# -Service Bulletin-

Re: 1996 - 2000 Chrysler 3.0L V6 Field Fix Kit

Voyager/Caravan/Lebaron/Daytona/Spirit/Dynasty/Monaco/Acclaim/Sundance/Premier

### OE System

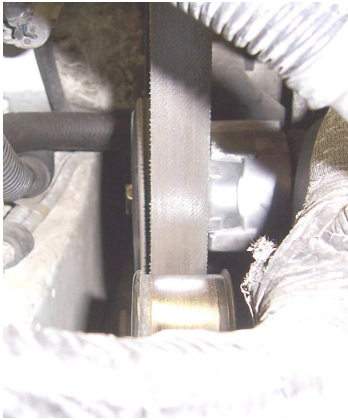
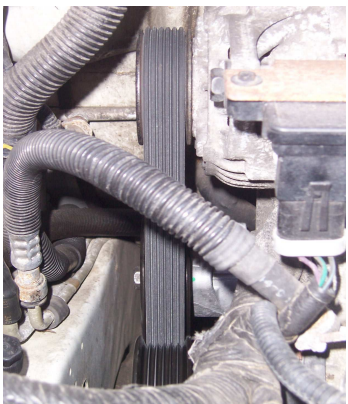
Notice the misalignment!

This picture shows the OE system. Notice how the system is causing the belt to become "misaligned". When this smooth tensioner pulley gets wet, the belt tends to slip off leaving the customer stranded.

Our field fix kit consists of a new tensioner (with a grooved pulley), a grooved idler and a "unique" double sided belt. This belt is unique because it has grooves on both sides and is the key to why our system performs so well. This type of belt design is highly recommended for serpentine belt drives that are sensitive to misalignment and poor tracking.

Unique double ribbed belt  
installed on the 3.0L V6.

This picture shows our system with the "unique" double ribbed belt design and grooved idler. Notice how "aligned" the belt is. This grooved system will not allow the belt to slip off any of the pulleys.
